ANP-2843Q1NP
Revision 0

LaSalle Unit 2 Nuclear Power Station Spent Fuel Storage Pool Criticality Safety Analysis with Neutron Absorbing Inserts and Without Boraflex - RAIs

June 2010

AREVA NP Inc.

Figure RAI-11.1: Most Reactive Bottom Lattices (0" to 96")

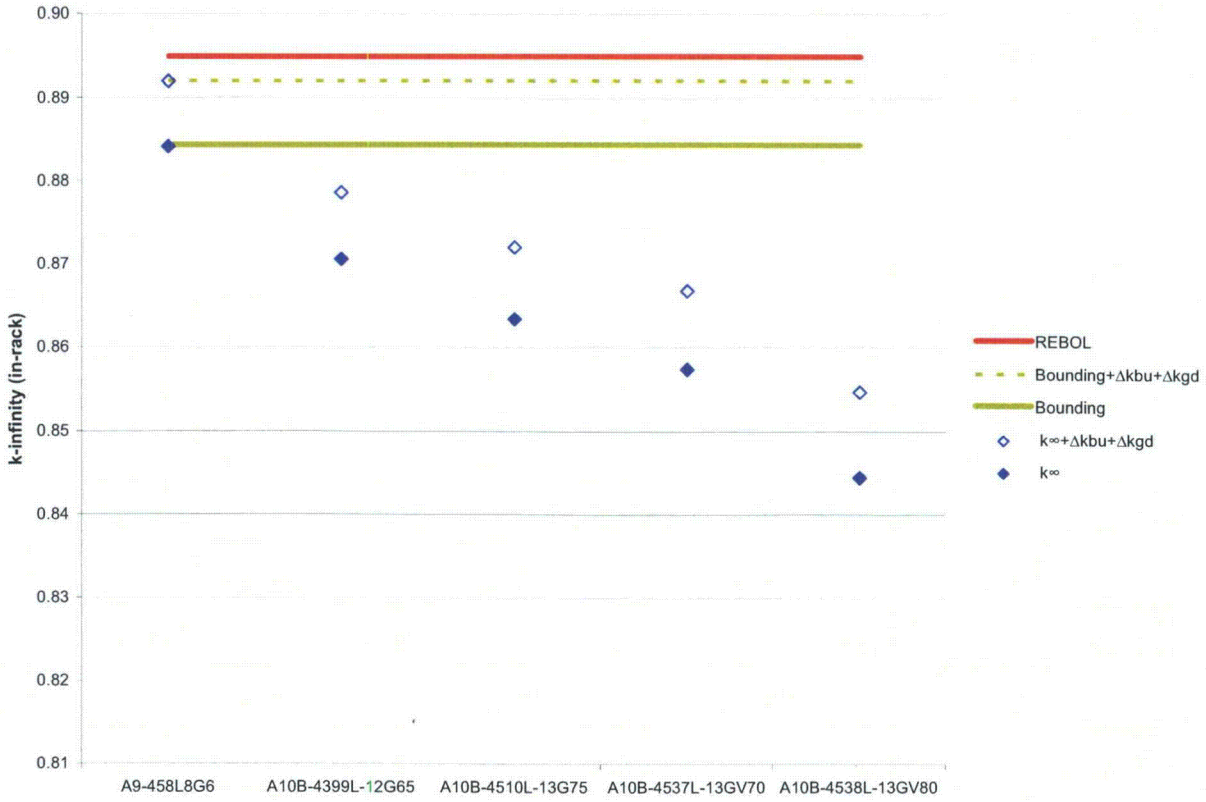
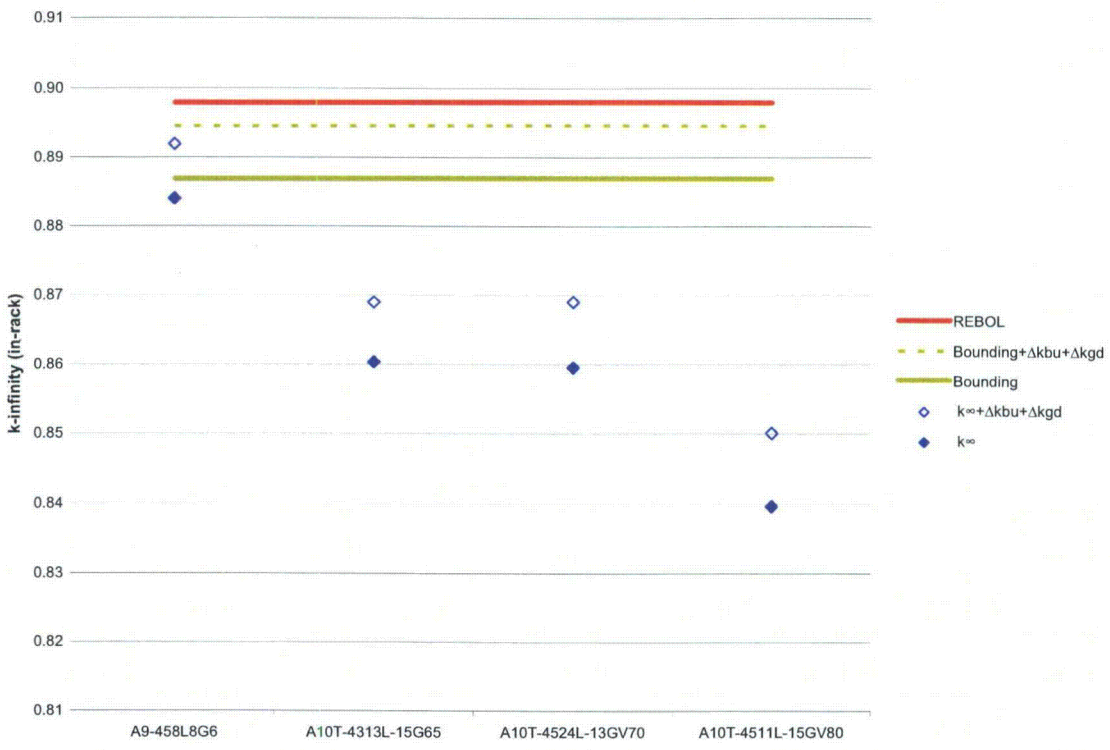
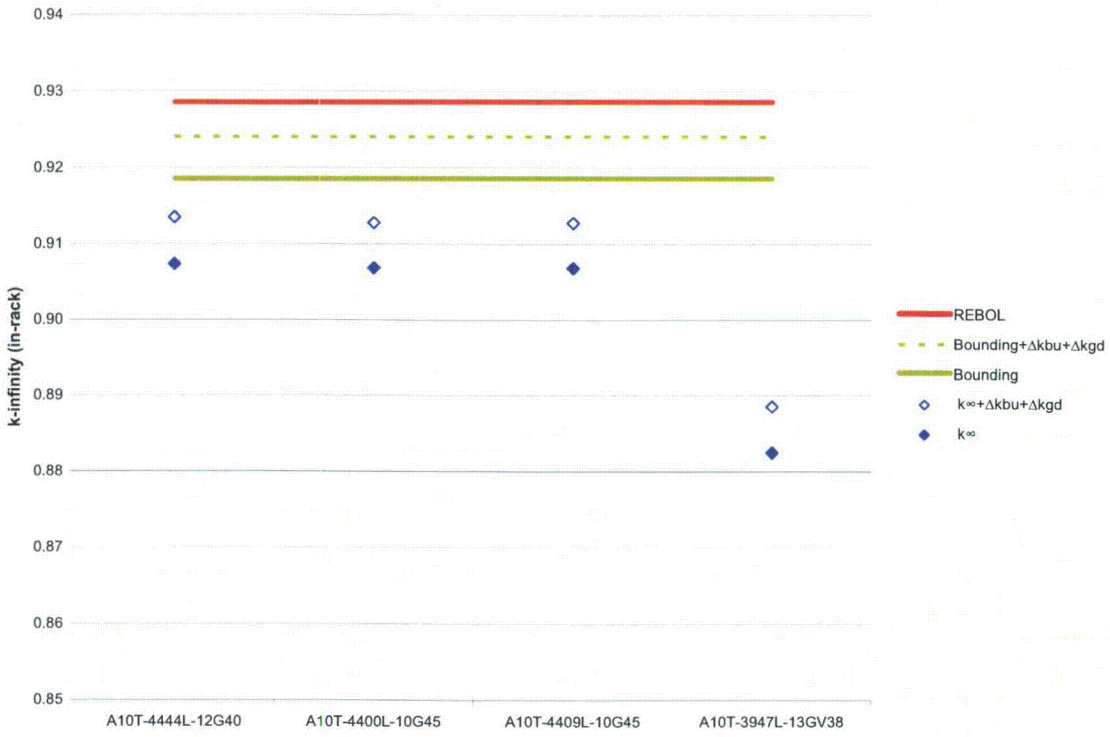
As noted above, design flexibility applies to future ATRIUM-10 assemblies since all current designs have been evaluated. The approach used in determining the bounding ATRIUM-10 lattice designs is illustrated in Figures RAI-11.1 through RAI-11.3. These figures graphically show the reactivity of each of the limiting lattices identified in Appendix B for the bottom,

intermediate and top elevation zones, respectively, of the ATRIUM-10 design. The corresponding bounding lattice and REBOL reactivities are also provided for comparison. (Note: The data in Figures RAI-11.1 through RAI-11.3 is plotted using four significant digits. This is consistent with the response to RAI-22 and not the three significant digits provided in Appendix B of ANP-2843(P).)

Figure RAI-19.1: Combined Assembly Rotation Scenarios

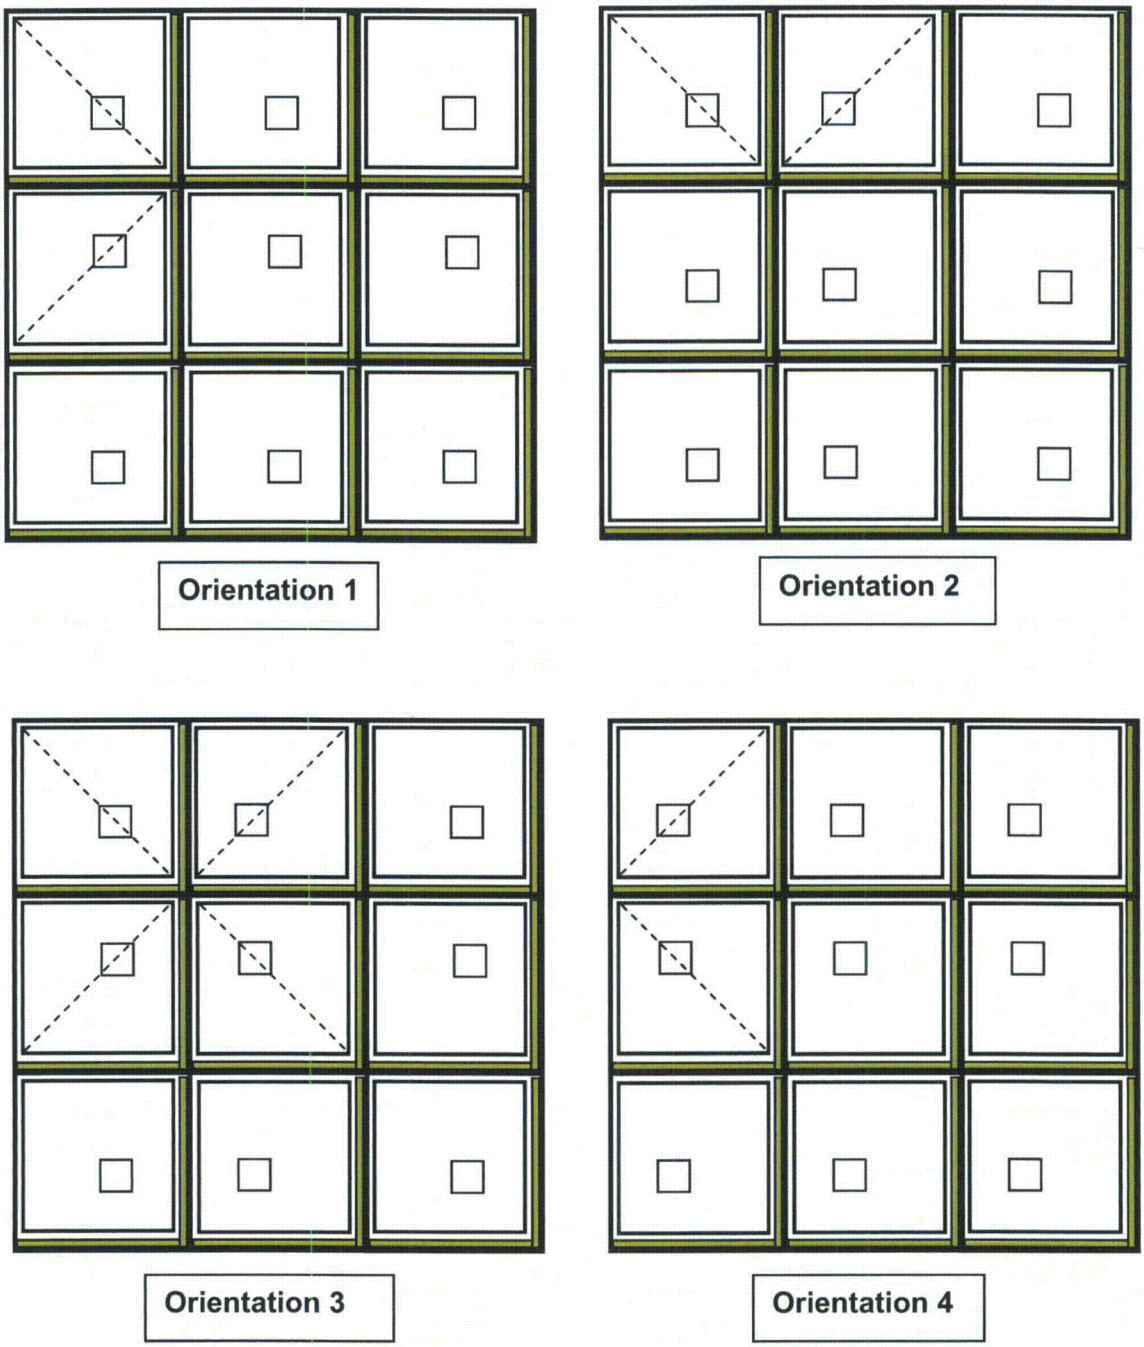
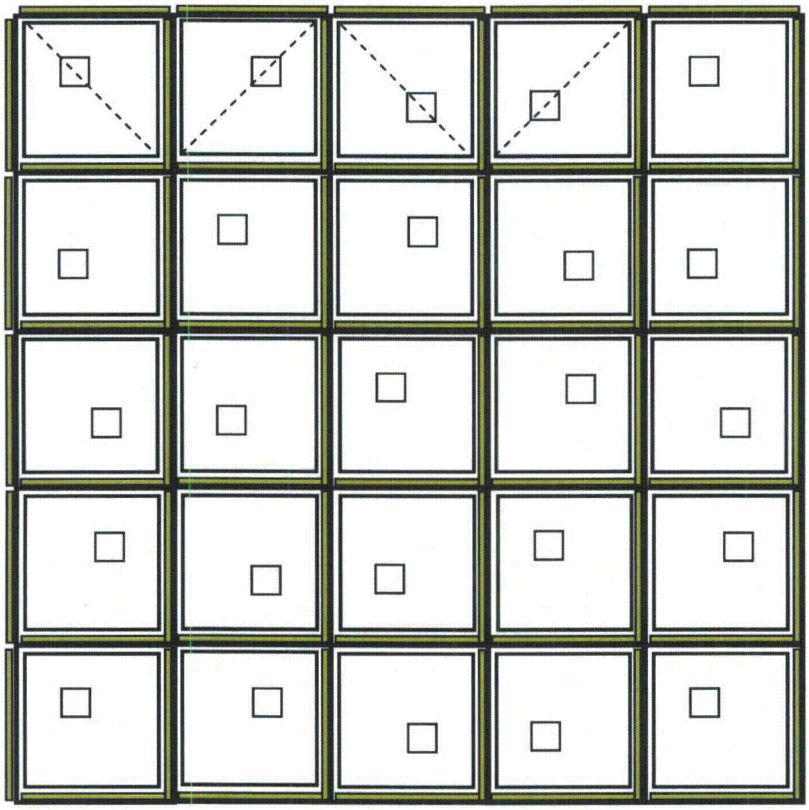
ANP-2843(P) (proprietary), Figure 4.2. Due to the off-center location of the water hole, assembly rotations should have been evaluated in conjunction with assembly groupings.

Provide more detailed discussion of assembly rotation studies performed so that the NRC staff may confirm that this issue was fully studied. What rotations and assembly locations were evaluated?

With the insert in the lower right hand corner, the four simple (0, 90, 180, and 270 degree) rotation scenarios have been evaluated on an infinite lattice basis. The zero degree rotation case (shown in Figure 4.2 of ANP-2843(P)) was selected as the base case because it was the most reactive of these four rotation scenarios. In addition, the five rotational combination scenarios shown in Figure RAI-19.1 were also investigated on an infinite lattice basis. Orientation 5 provided the highest reactivity result with less than a 0.001 Δk increase. In all instances the fuel assemblies were centered in the water region of the storage cells.

RAI-24 indicates that optimization studies should be performed for the accident scenarios. Translation studies for the rotated assembly are not required because the centered position already provides a near optimal water gap. The reactivity increase from the rotated assembly scenario (0.001 Δk) is small in comparison to the optimized missing insert scenario (0.003 Δk) discussed in the response to RAI-24.

Figure RAI-22.1: Depletion Penalty Assessment

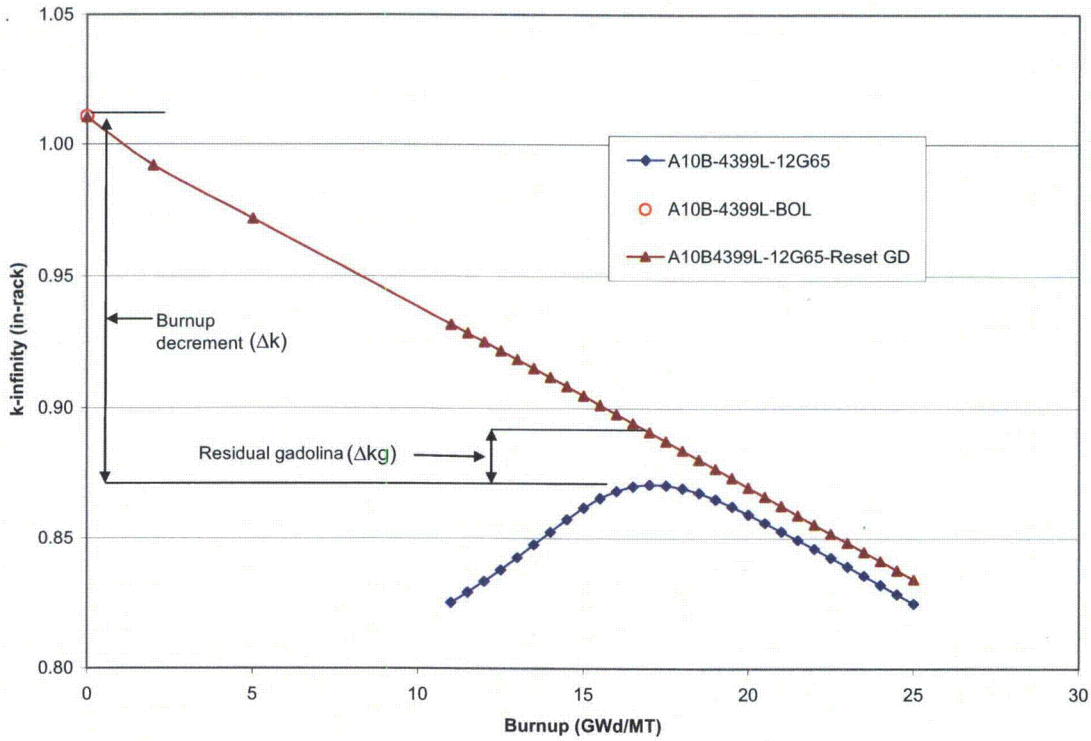
Provide additional justification for the 0.01 Δk margin used to account for calculational and depletion uncertainties.

Based on the calculation process illustrated in Figure RAI-22.1, 5% of the burn-up reactivity decrement (Δkbu) and 5% of the residual gadolinia reactivity change (Δkgd) are tabulated in Table RAI-22.1 for the reference bounding lattices. Also tabulated is an adjusted k_∞ in which both the burn-up and gadolinia reactivity impacts are added to the peak reactivity value which allows comparison to the actual REBOL reactivities.

These results demonstrate that the 0.010 Δk added to the k_∞ of the reference bounding lattices when defining the enrichment level of the REBOL lattices is sufficient to account for the code bias and uncertainty associated with the fuel depletion and nuclear data library errors because the maximum depletion uncertainty for the reference bounding lattices is 0.0078 Δk, (i.e. less than 0.010 Δk).

Figure RAI-24.2: Limiting Missing Insert Condition

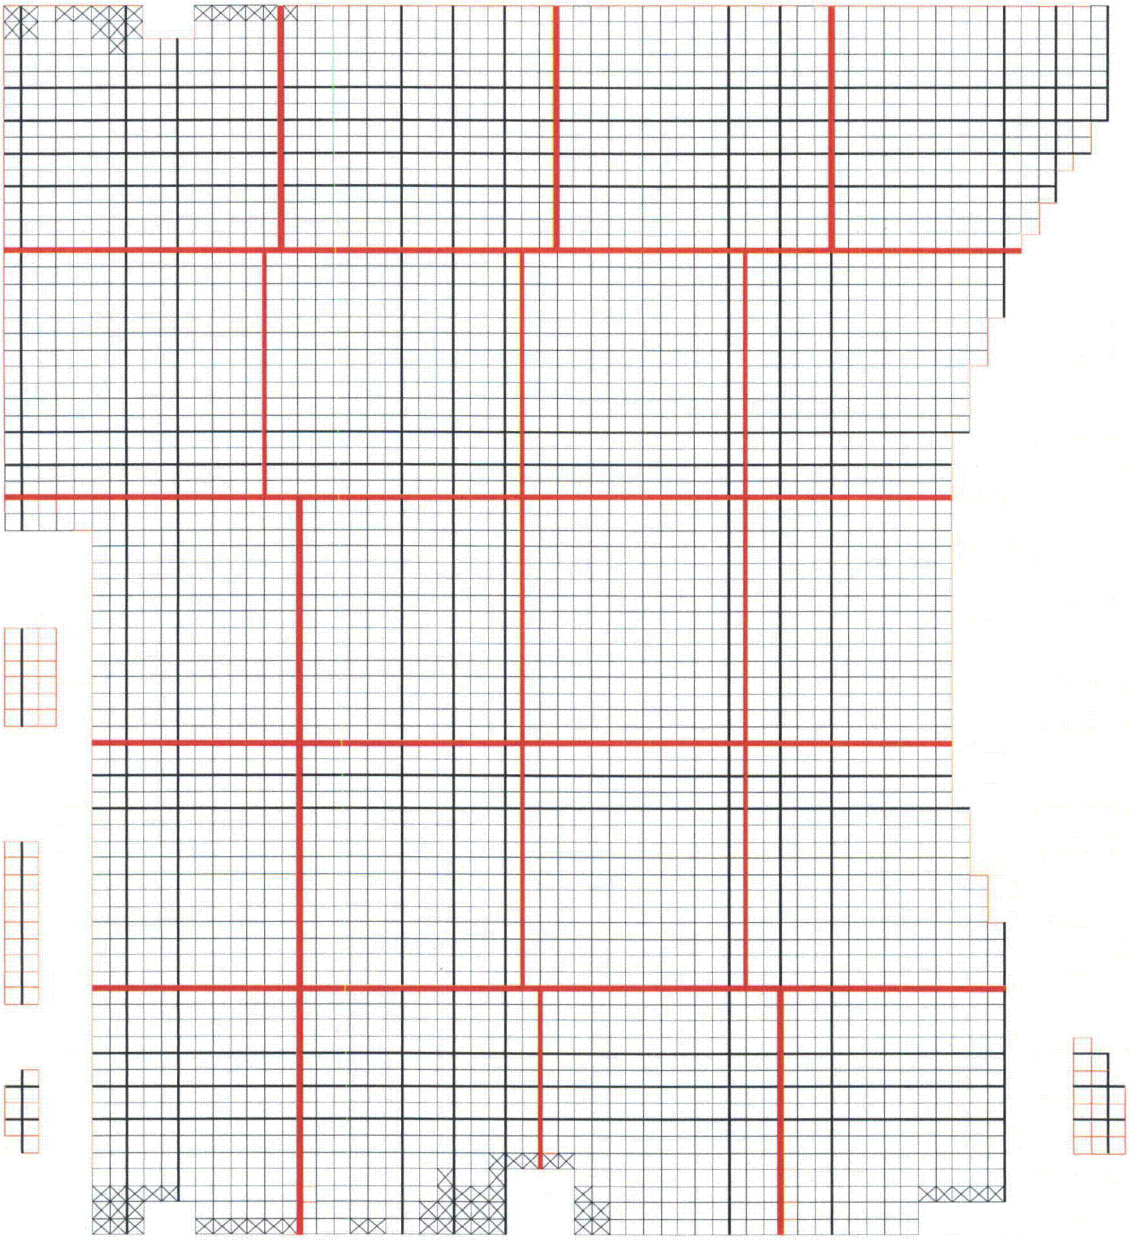
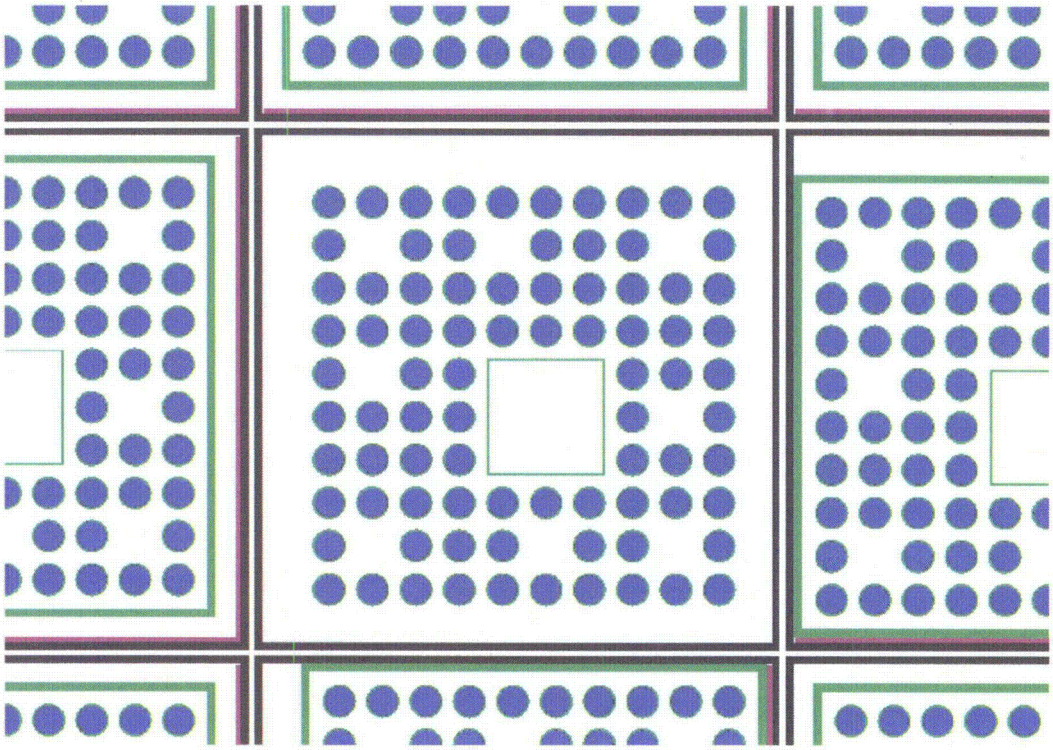
Confirm that an assembly placed into an interior corner of three rack modules, with outer walls not covered by inserts (see figure), was evaluated. The analysis should also look at variations in spacing between the external assembly, with and without fuel channel, and the storage rack modules.

The misload scenario described here and pictured in RAI-5 for an assembly placed in a corner formed by three rack modules (as opposed to placement of an assembly next to the side of a fuel storage rack module) can occur at numerous places outside of the storage cell locations. However, due to the physical configuration of the pool storage array, any such misloading of an assembly in the corner between storage racks is limited to a configuration where the corner extends for a maximum of only five rows or five columns of stored fuel in the east-west or north-south directions (see Figure RAI-24.1). This limiting configuration (using a channeled and unchanneled fuel assembly in the corner) has been evaluated with the face adjacent assemblies in the center of the water region (maximizing reactivity) and the misloaded assembly in close proximity to the corner. This evaluation produced a case with a 0.0016 Δk increase in k-eff.

The missing insert scenario has been evaluated under the five optimized conditions listed below. Condition 3 with the unchanneled assembly near the center of the cell (see Figure RAI-24.2) was found to be the most reactive situation with a final k-inf 0.0002 Δk higher than found in the original calculation. There was sufficient rounding margin included with the result reported in ANP-2843(P) that the limiting accident worth of 0.003 Δk is still supported. It is now confirmed that the limiting accident scenarios have been evaluated with effort to maximize the reactivity.

Figure RAI-39.1: Evaluation for Pu Trend

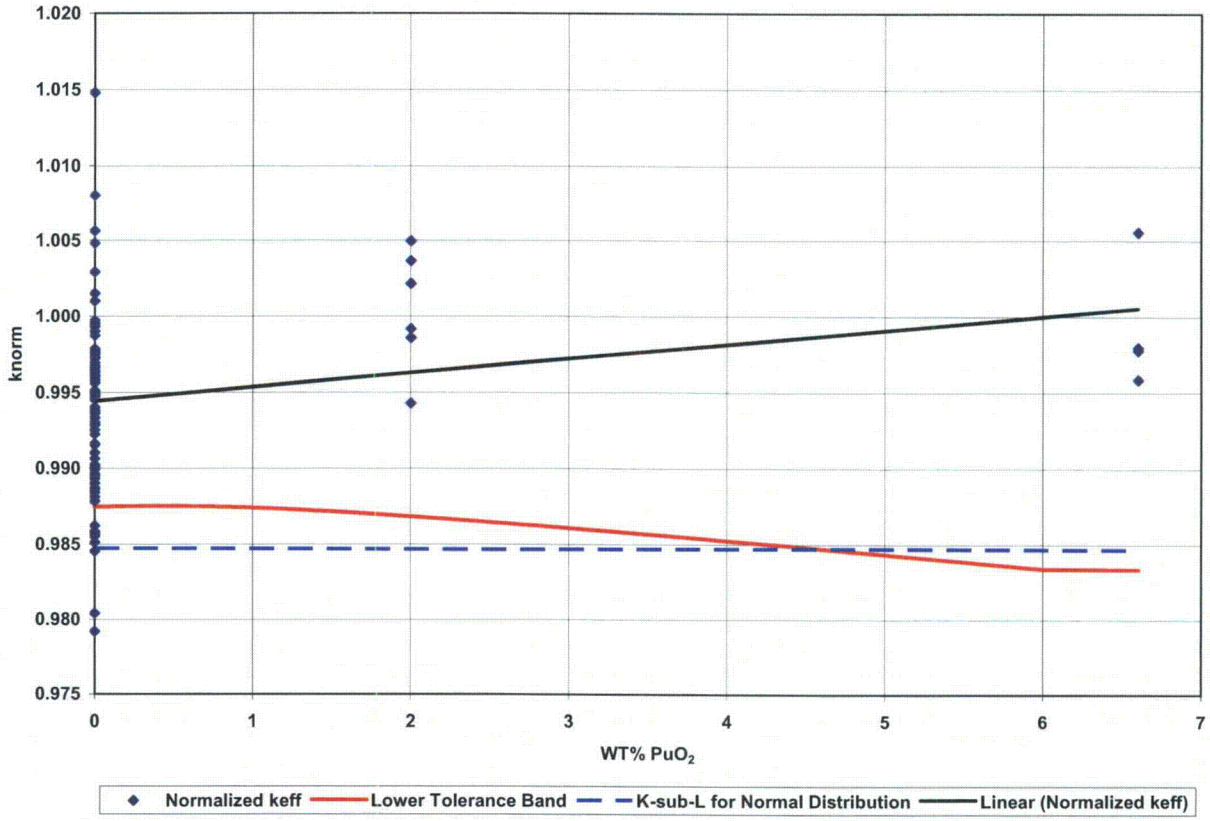
For validation of fresh fuel calculations, remove the MOX experiments from the validation set and recalculate the bias and bias uncertainty.

This approach of including the MOX criticals in the ANP-2843(P) analysis is questioned in the RAI above. To demonstrate that this approach remains reasonable, a trending comparison with Pu content is shown in Figure RAI-39.1. This figure demonstrates that the current application of the 95/95 lower tolerance limit for a normal distribution (K_L) is more limiting at 0 wt% Pu than the lower tolerance band that accounts for the trend line. In addition, Table RAI-39.1 shows a comparison of parameters for the full set of 100 benchmarks versus the reduced set of 89, which excludes the MOX criticals. The bias and bias uncertainty results do not change significantly and the 95/95 lower tolerance limit for a normal distribution (K_L) values are identical to 4 significant digits. Therefore, this set of 100 cases remains applicable for the method uncertainty determination.
